Release Note

Edgecore EAP101 Release v12.4.1

Document # EAP101-v12.4.1-1039-c32b0269

Enhancement from v12.4.0-971-24746b8b

1.1 Access Control List Enhancement

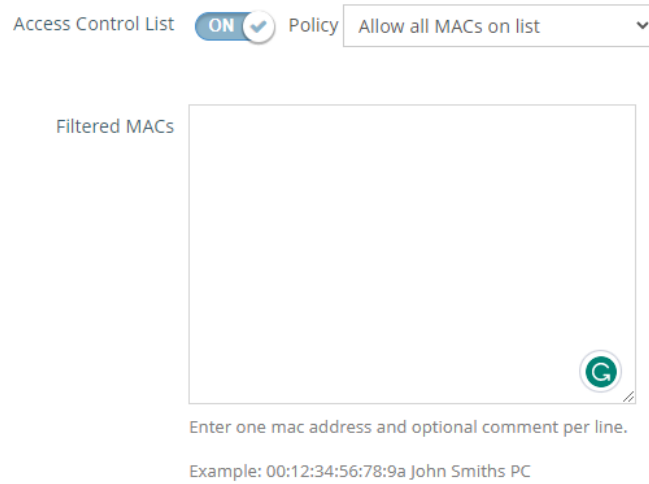
The original number of MACs in the access control list is 128. In this version, the number of MACs is increased to 512 for all policys.

1.2 User Account Enhancement

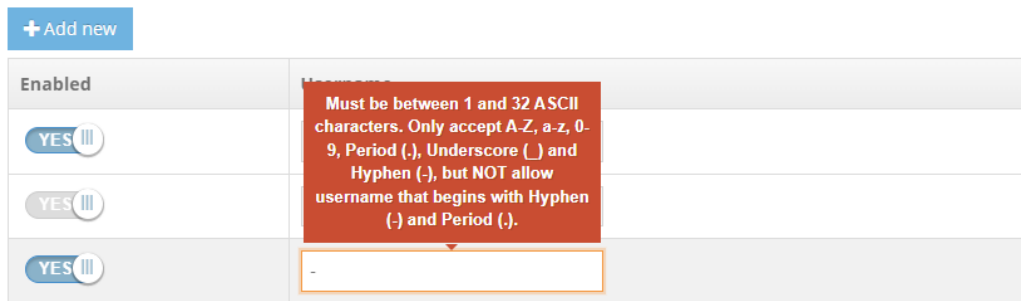
Add the validation for user accounts below.

1. Username - Must be between 1 and 32 ASCII characters. Only accept A-Z, a-z, 0-9, Period (.), Underscore (_) and Hyphen (-), but not allow username that begins with Hyphen (-) and Period (.)
